### ADDENDUM 1

## Austin Elementary School Heating & Air Condition (HVAC) Improvements Funded through the Elementary & Secondary Emergency Relief (ESSER) Funds May 31, 2022

## Addendum

**PROJECT** 218007.004 | Edinburg CISD - Stephen F. Austin ES - HVAC Improvements

SHEET NUMBER:  
M3.01

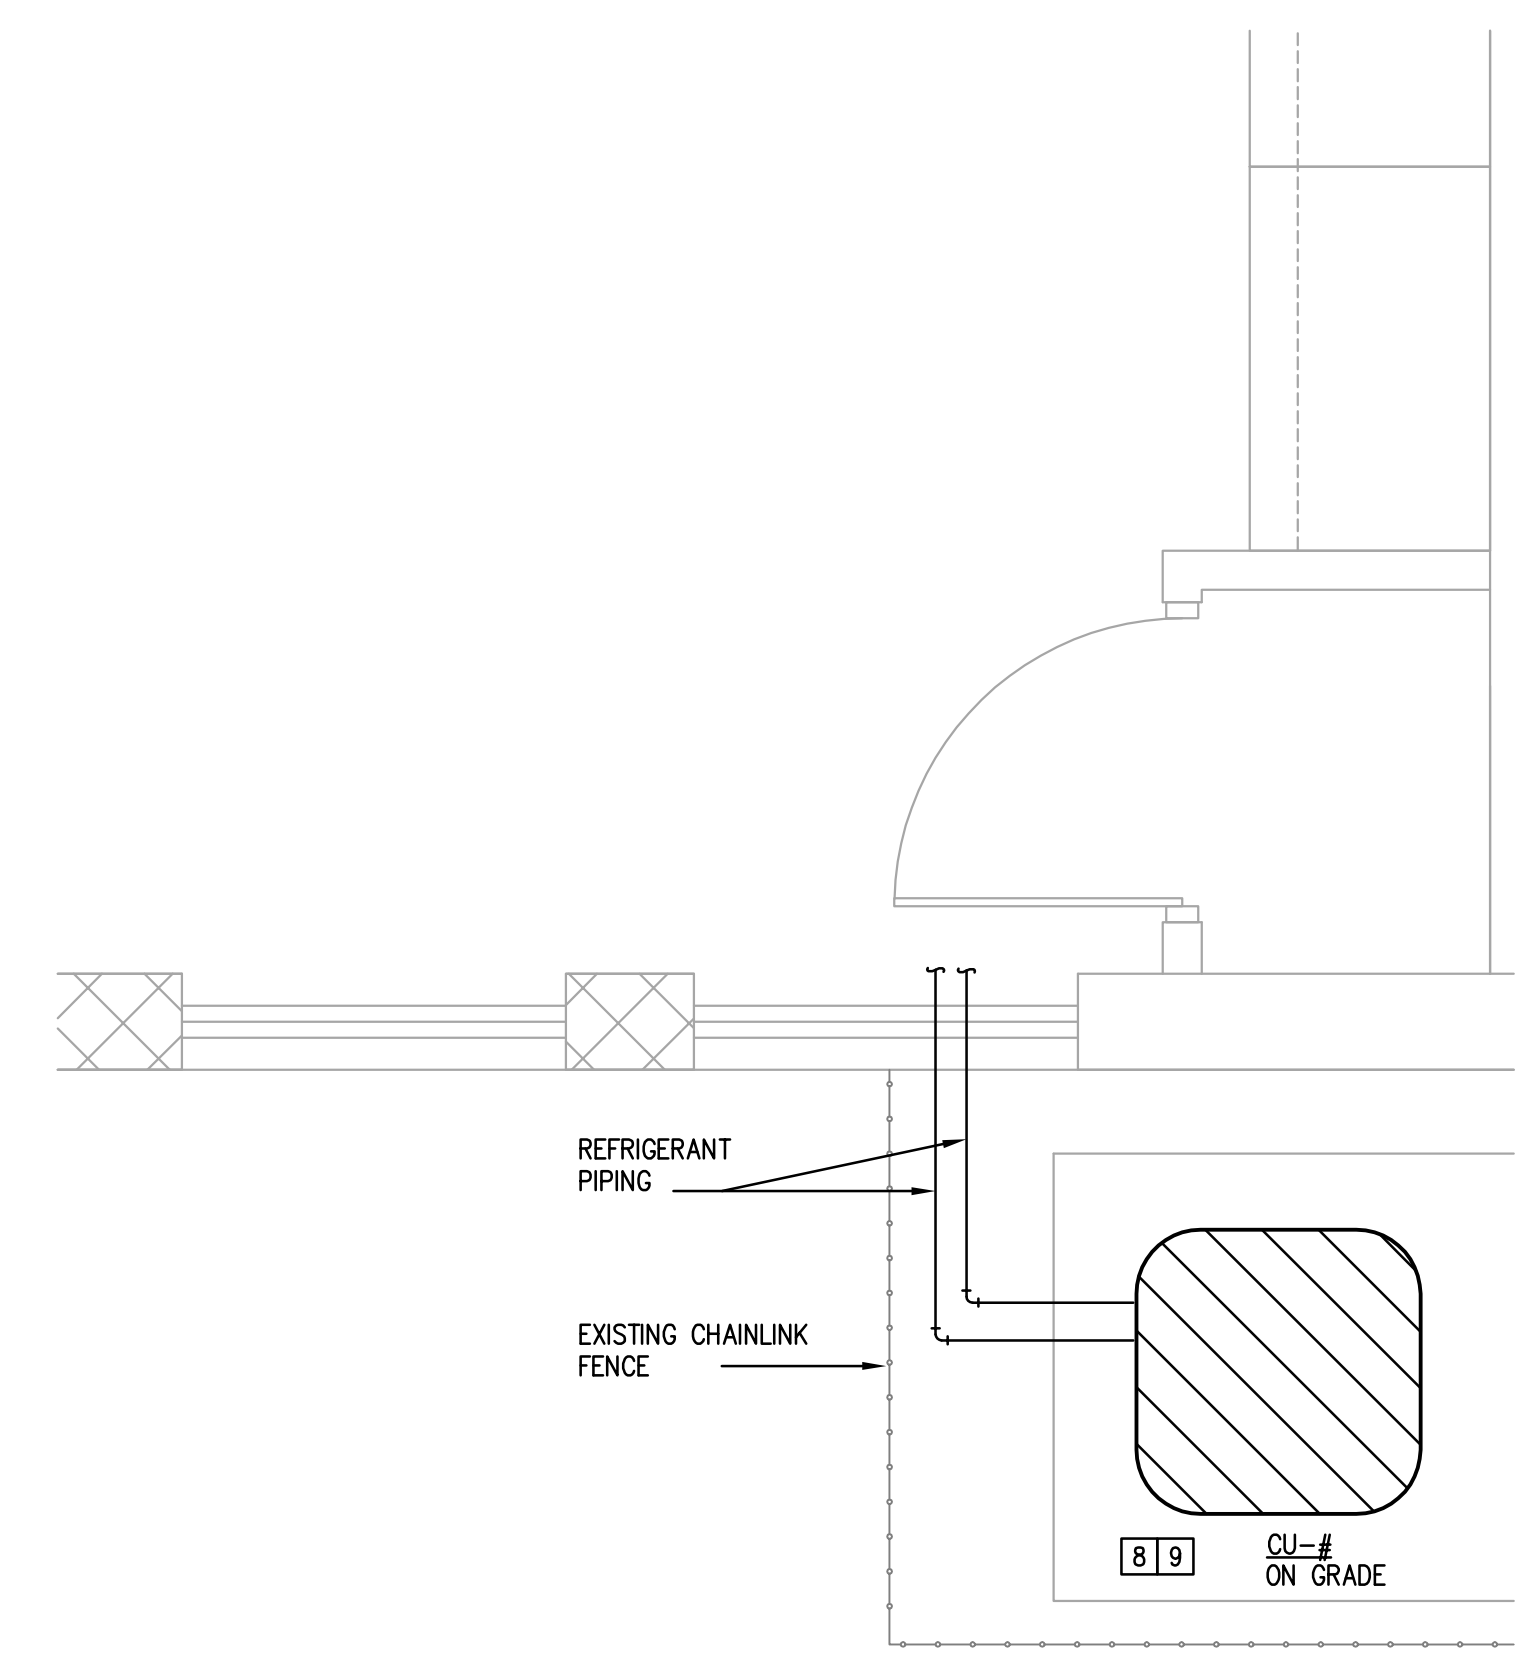
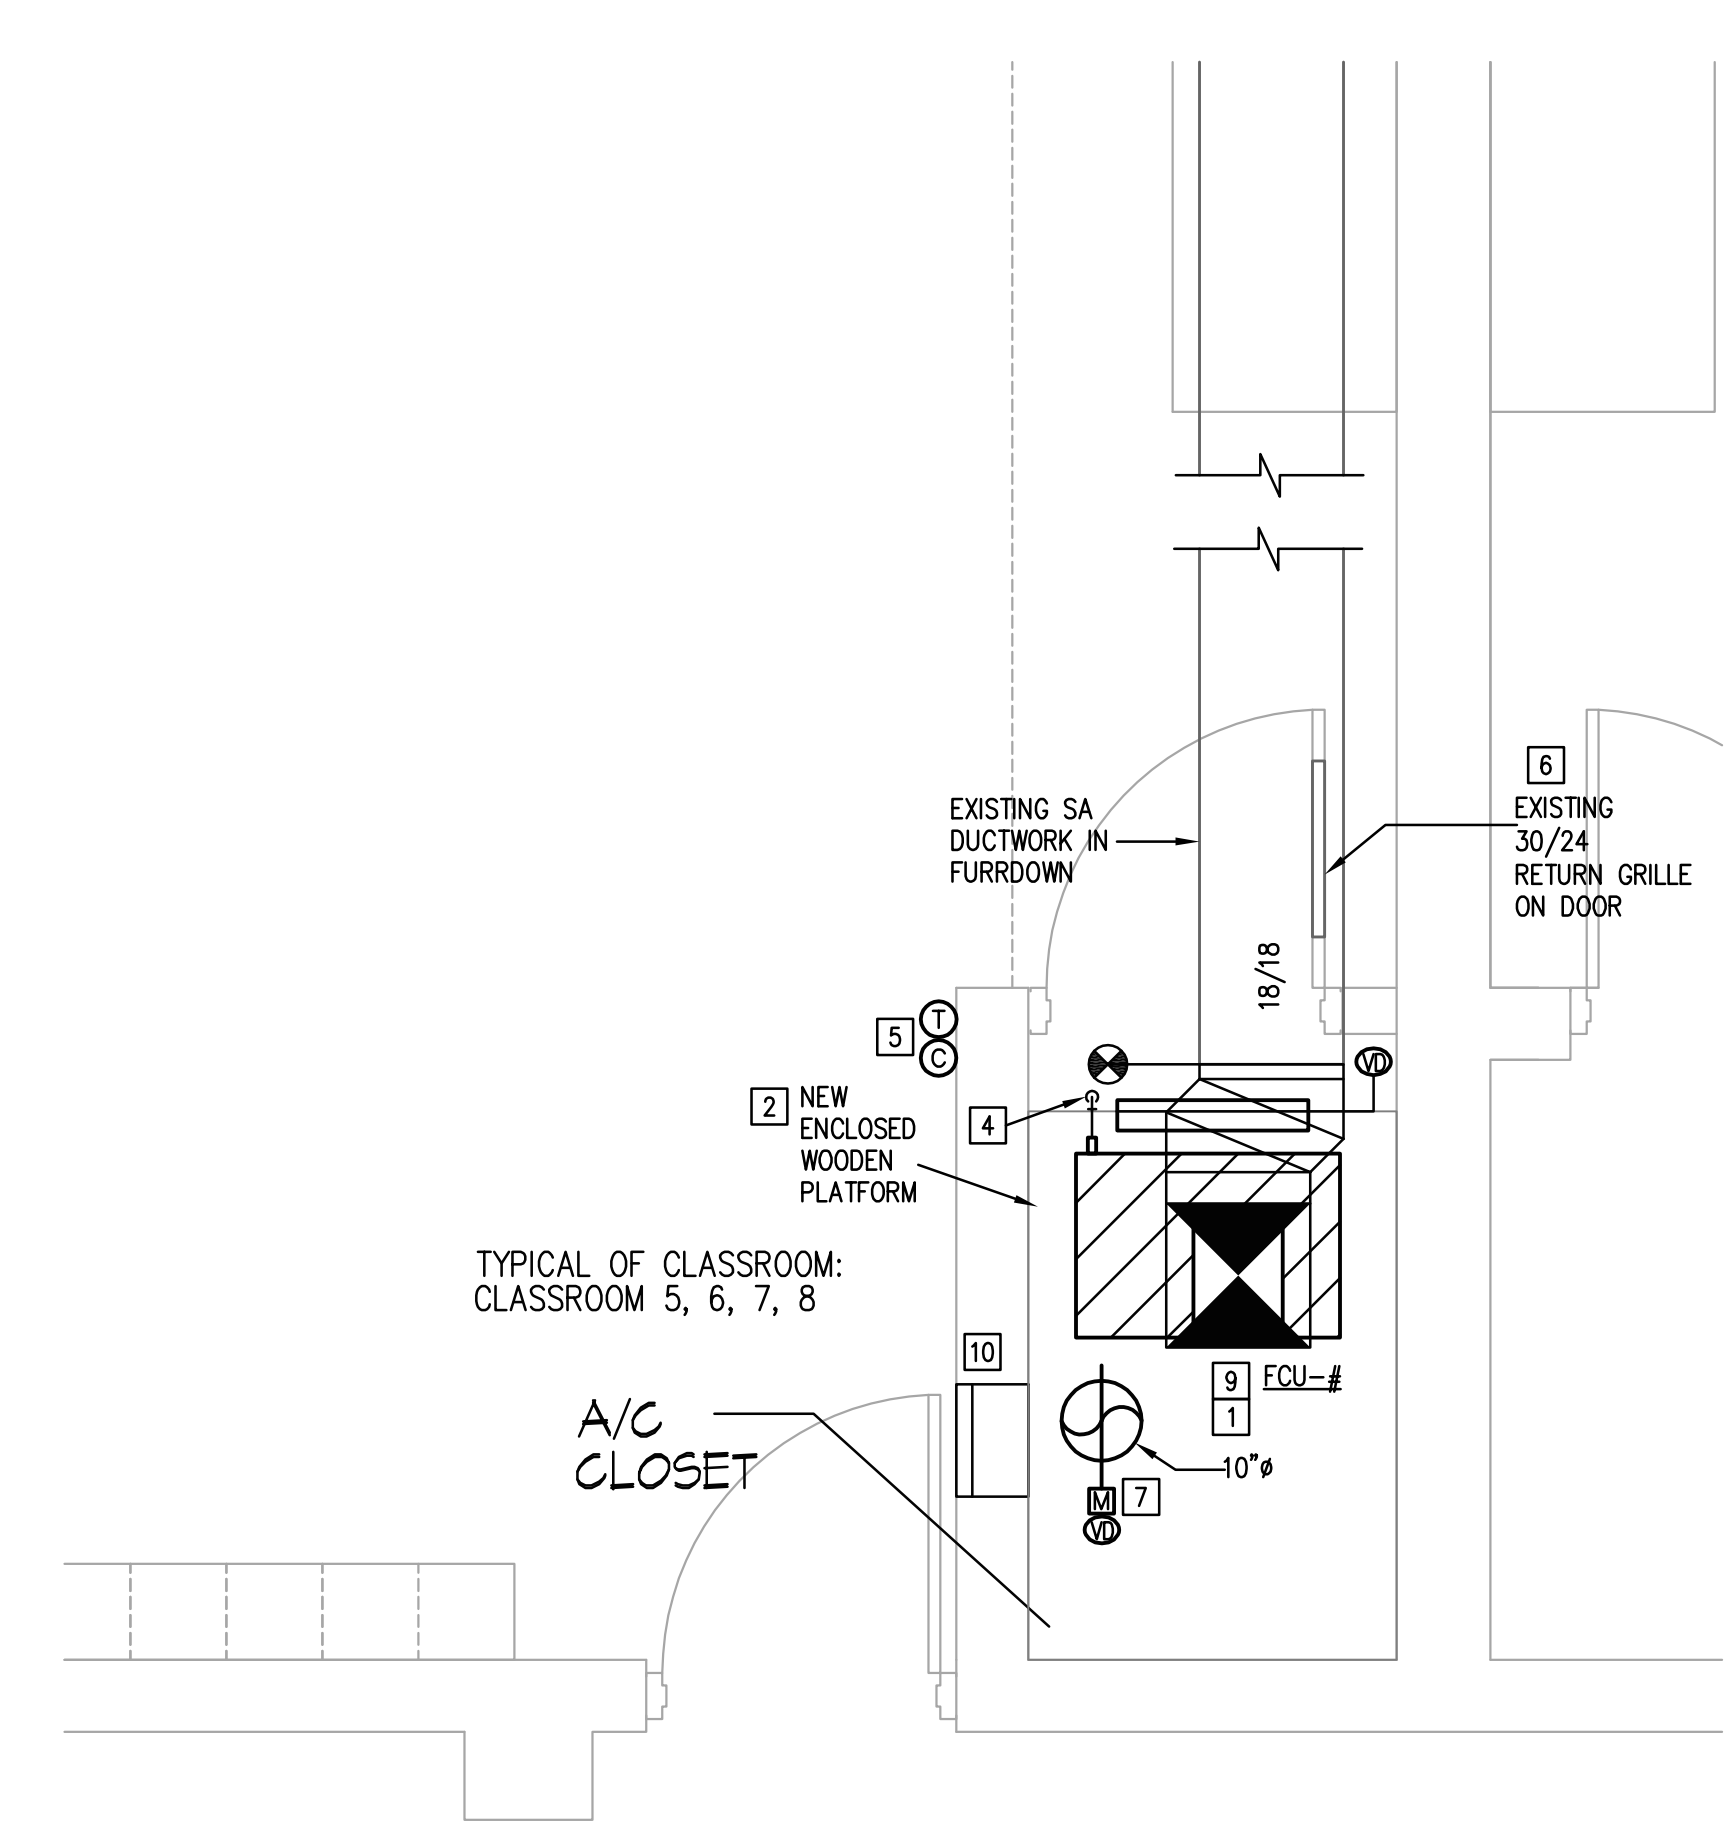
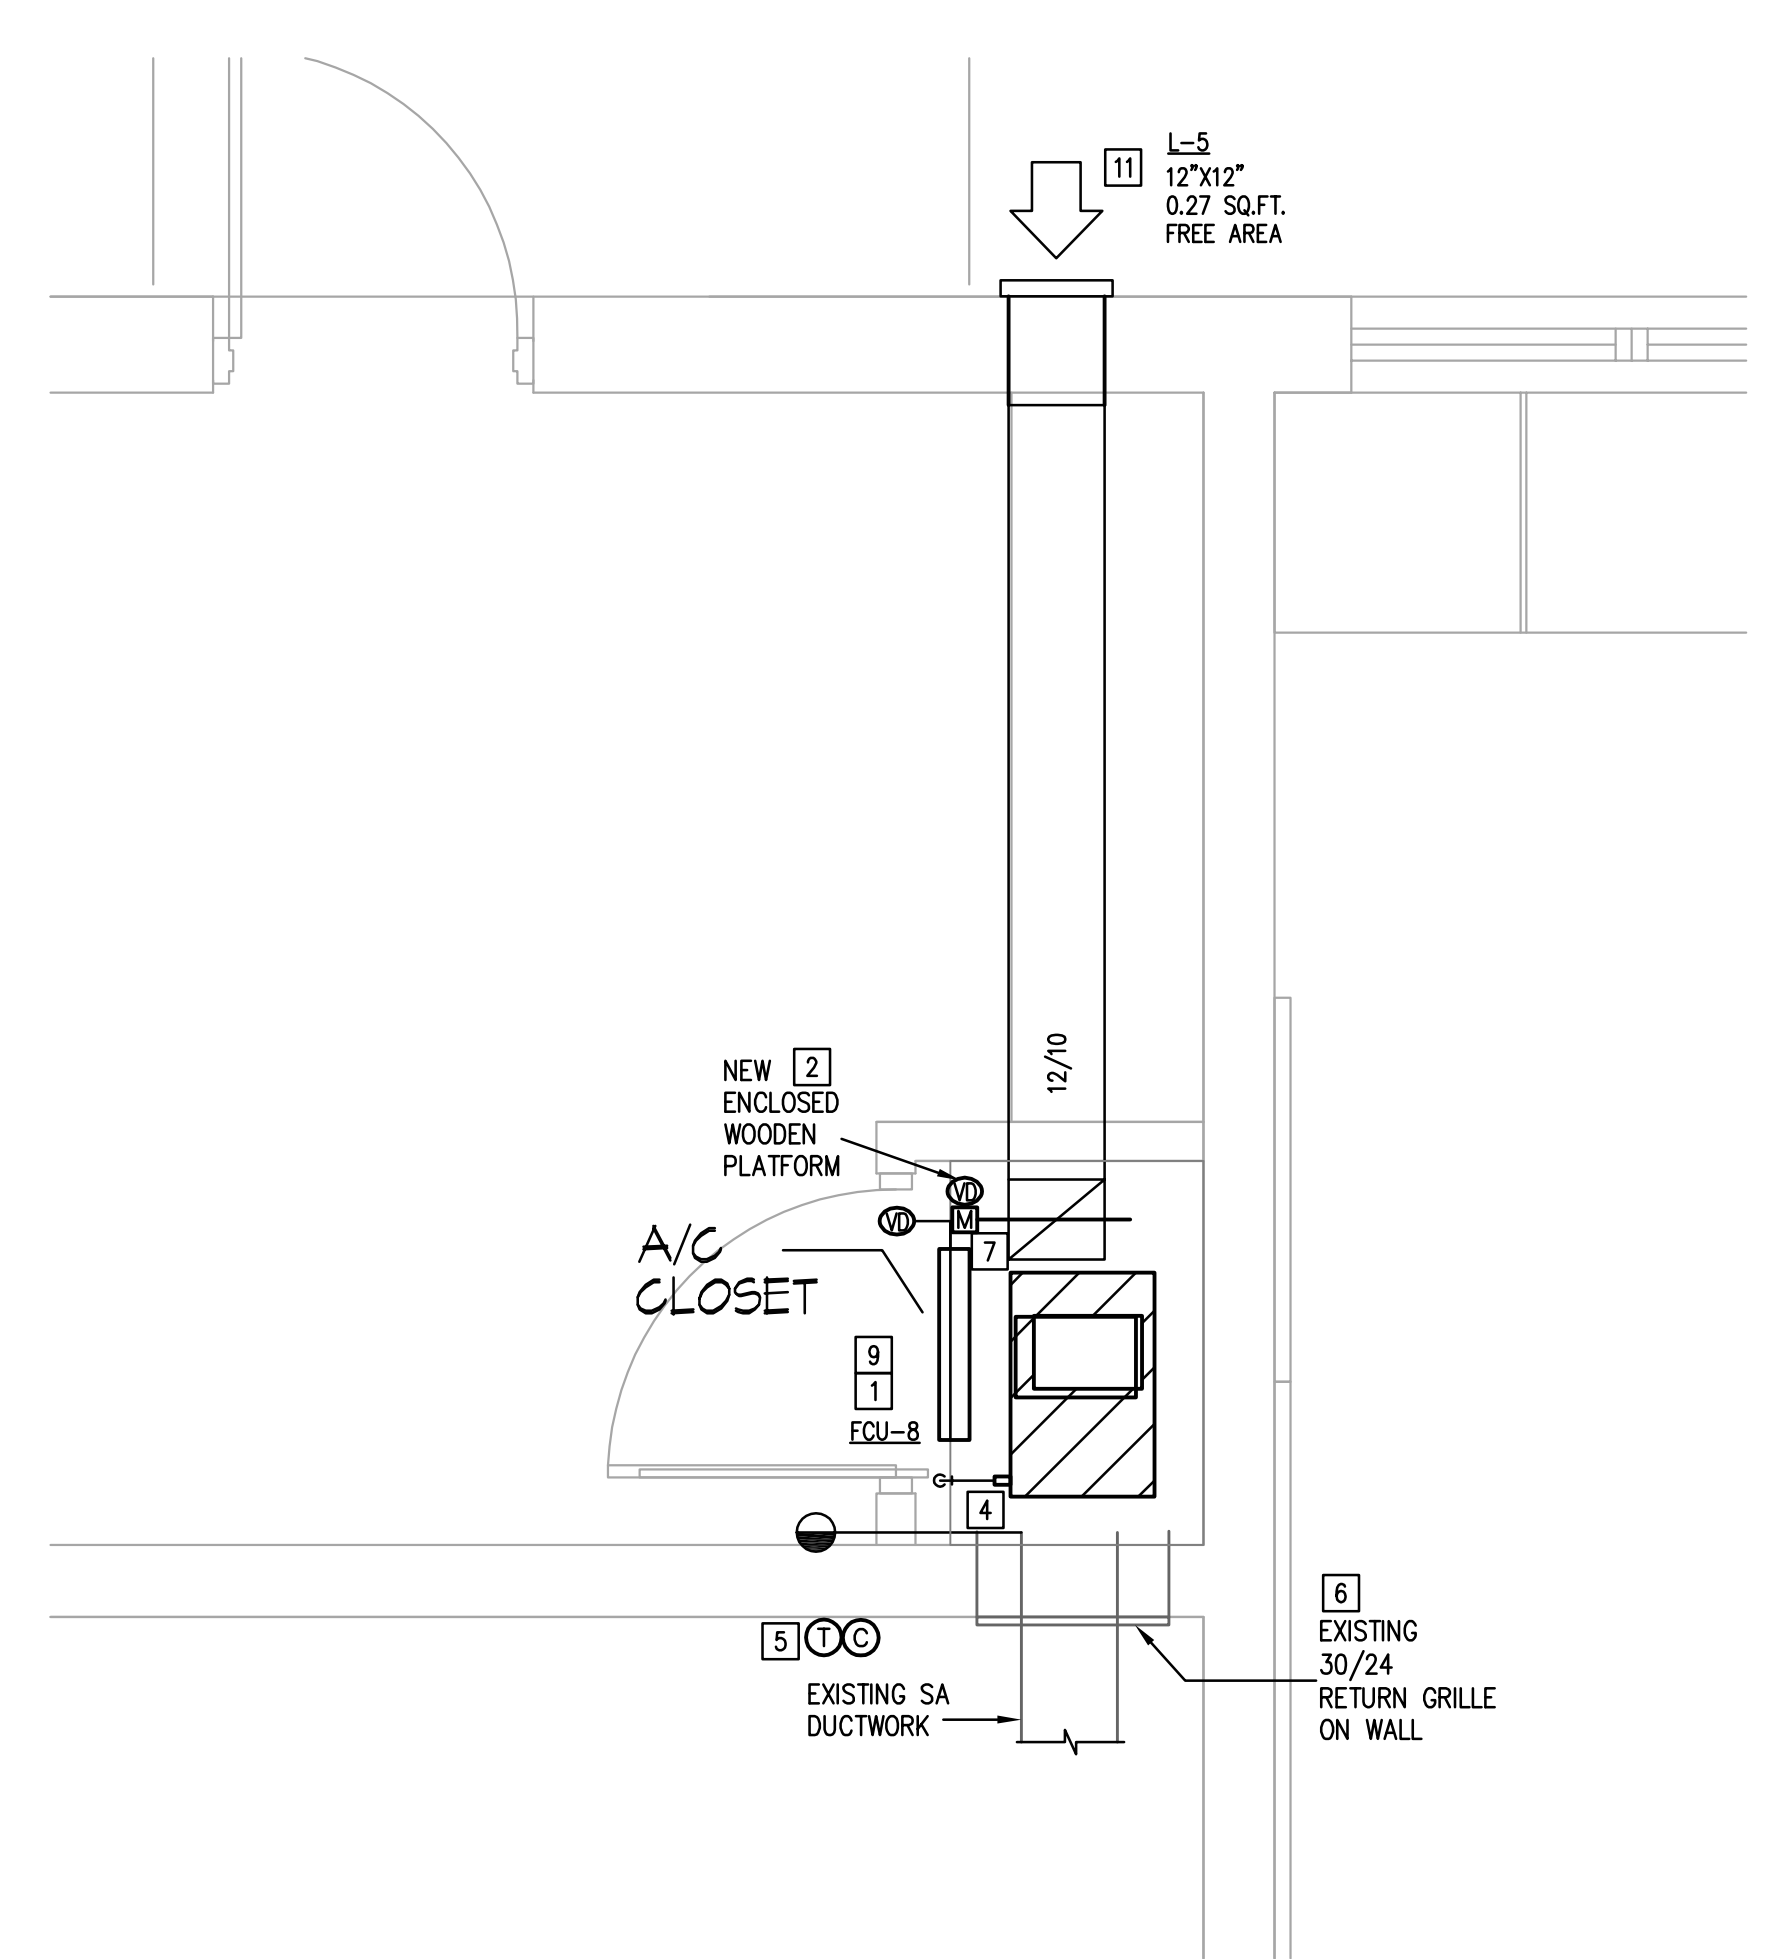
**Item 09 M3.01 – Enlarged Mechanical Plan**

- A. Revised keyed note 7.
- B. Indicate volume dampers
